2.3 DA/846/2012 - Proposed Detached Secondary Dwelling at 6 Hillcrest Avenue, Tacoma

TRIM REFERENCE: DA/846/2012 - D03371169

AUTHOR: Jason Ritson; Health and Building Surveyor

SUMMARY

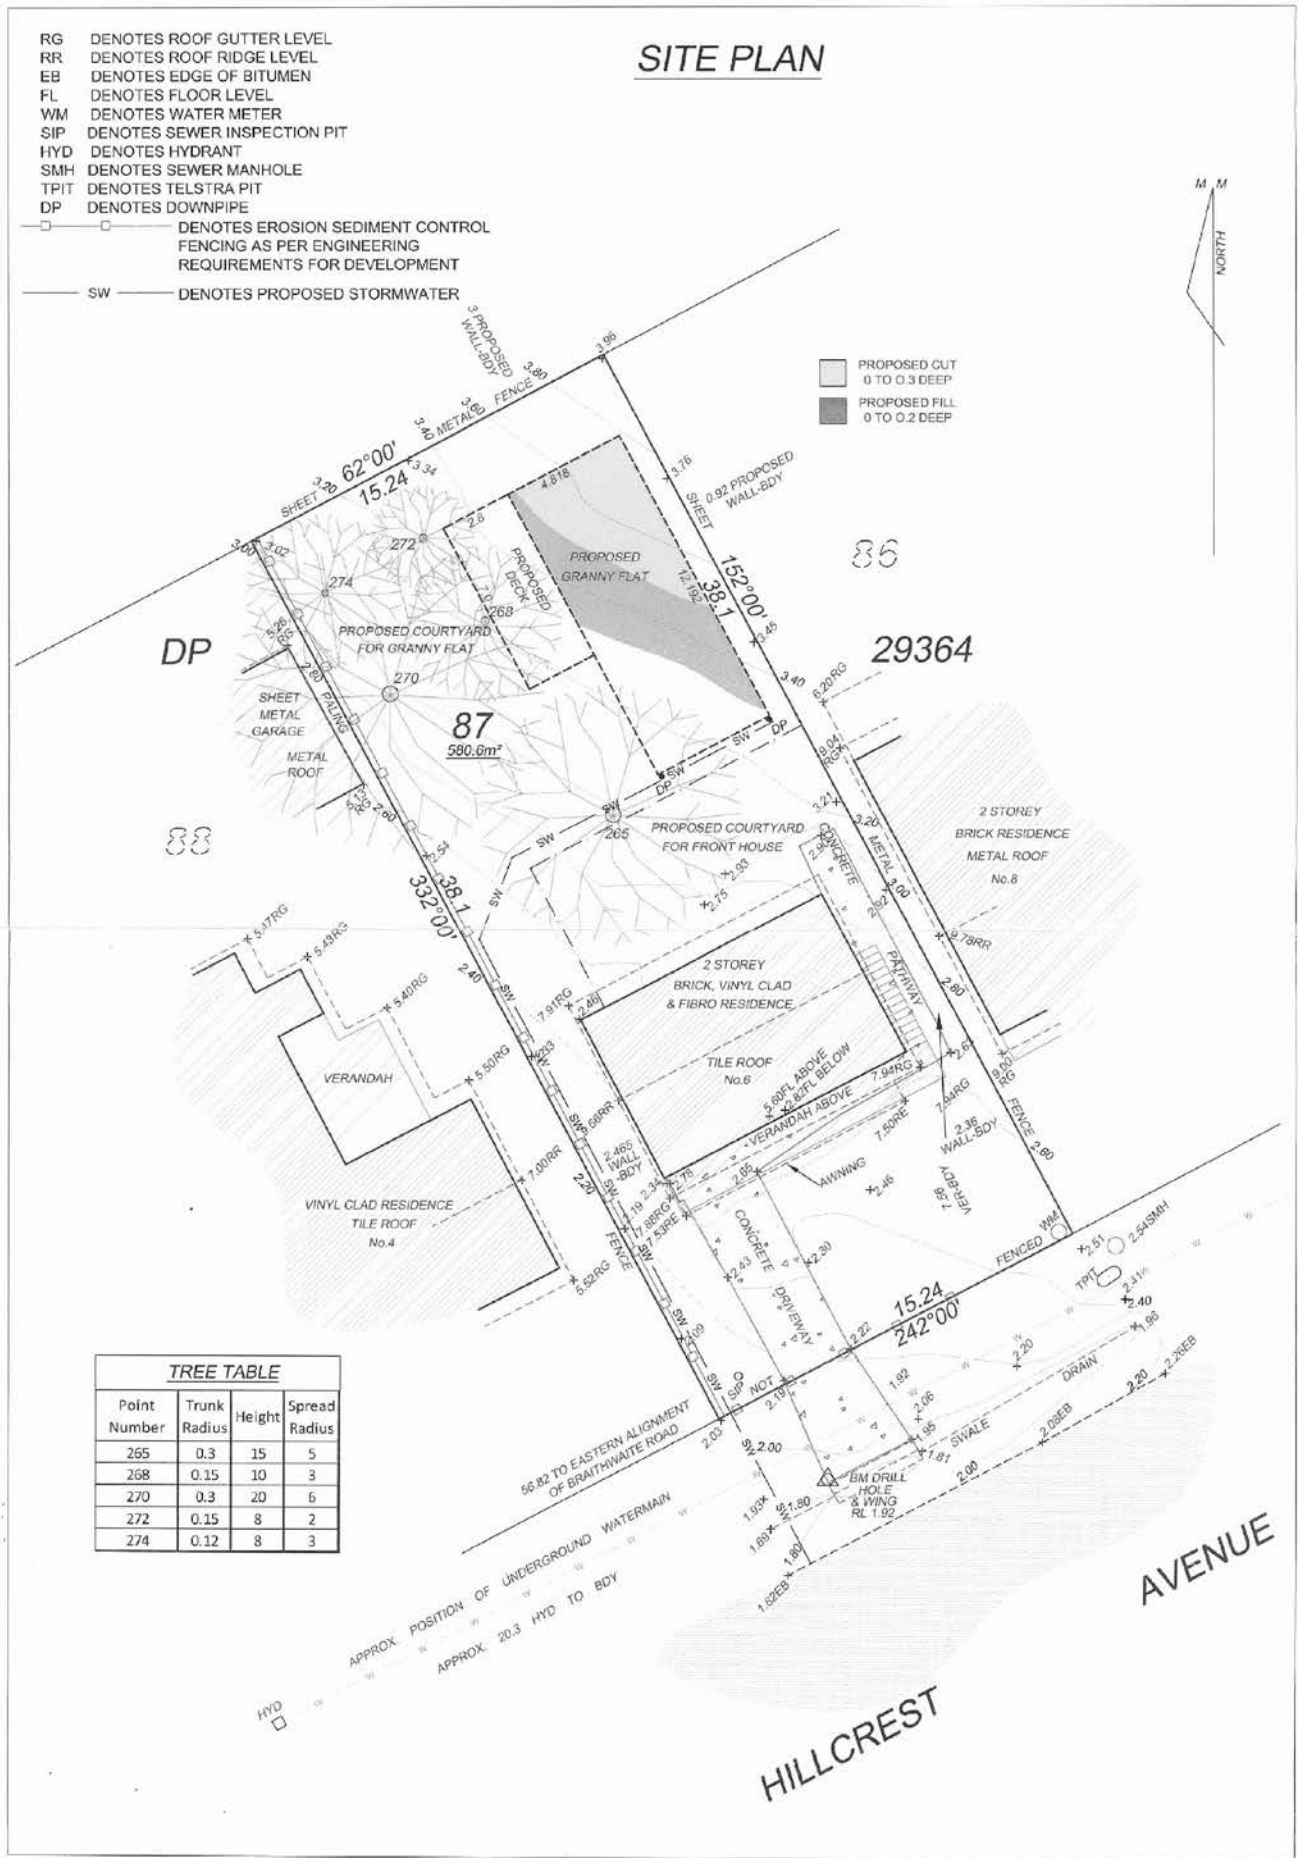
- 4 Amend the site plan to include the location of the 2500 litre water tank.

Figure 12: Proposed Site Layout

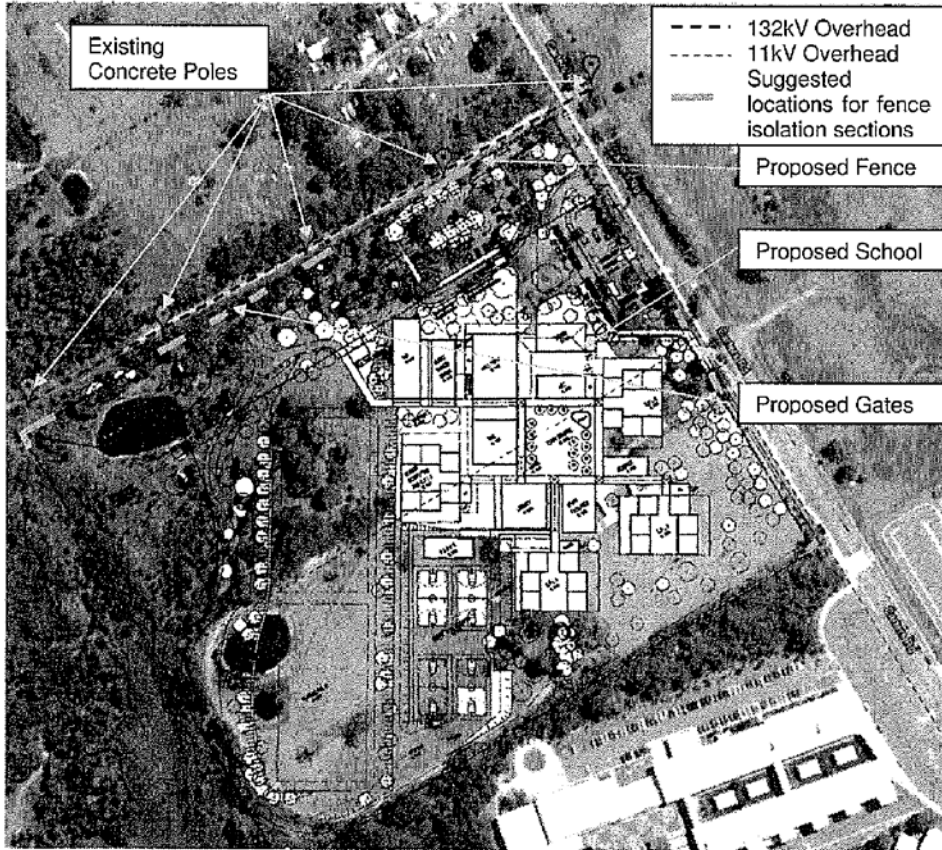
- The metallic fences within 12m of the concrete poles shall have timber isolation sections installed every three (3) metres. Refer to attachment drawing number 127869 in Figure 13.
- The fence shall not be bonded to the MEN or connected to any other metalwork which is in contact with the MEN such as lighting circuits.
- Any taps or other metallic objects within 2m of the fence along the easement must have an isolating (PVC) section of at least 3m installed.
- No LV electrical wiring or appliances within 2m of the easement fence.
- No telecommunications pits or pillars within 8m of the concrete poles.
- Timber isolating sections separating gates from long metallic lengths of fence

Possible locations of the isolation sections are shown in Figure 12.

Figure 13: Example Earth Break Panel Fence Drawing

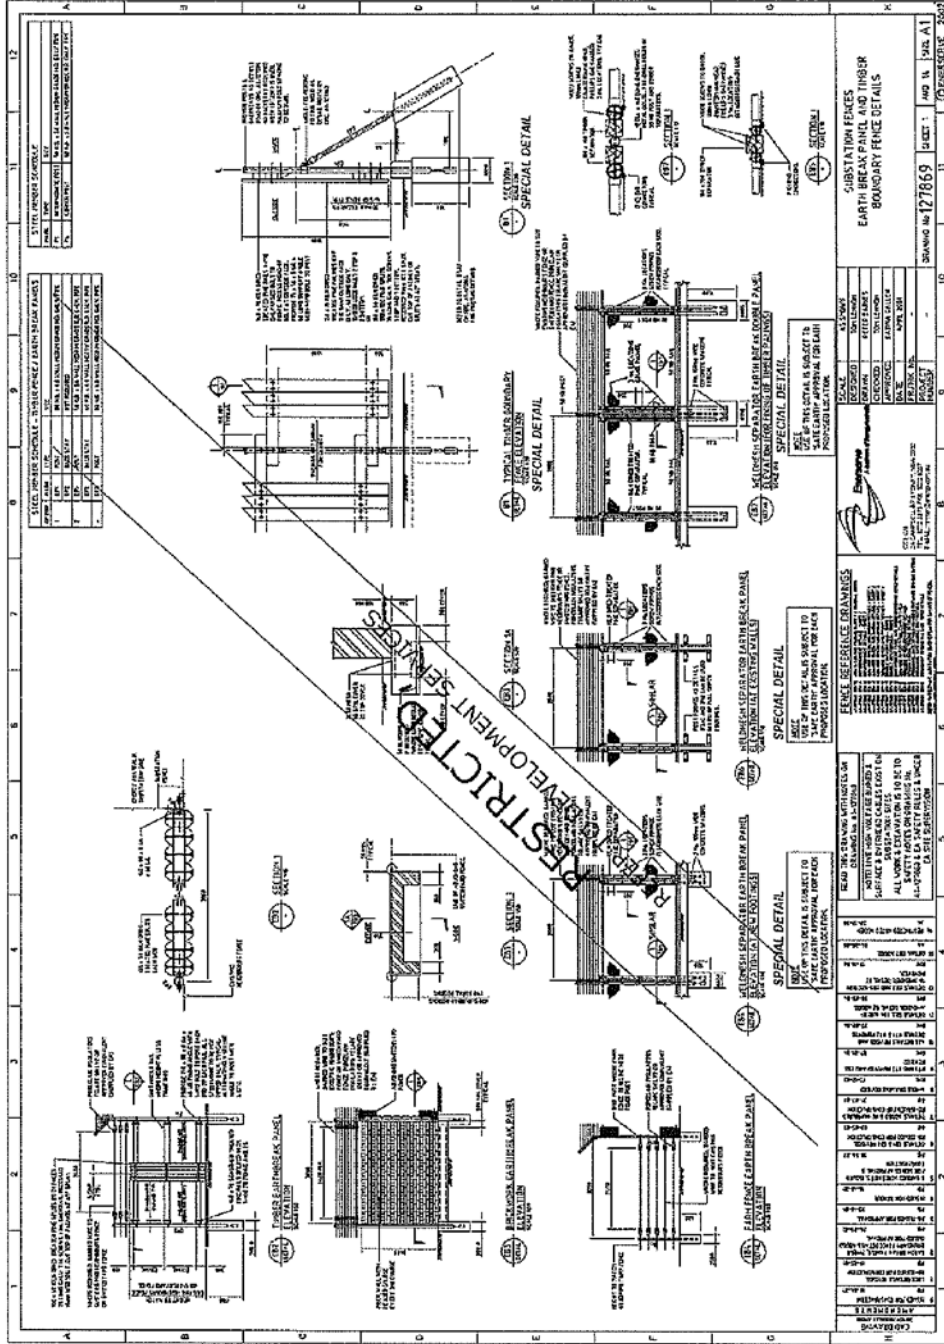
It is recommended that conductive infrastructure with a high contact rate, such as gates, be isolated from long sections of conductive fencing with timber separators such as that shown in detail EB7 in Figure 13.
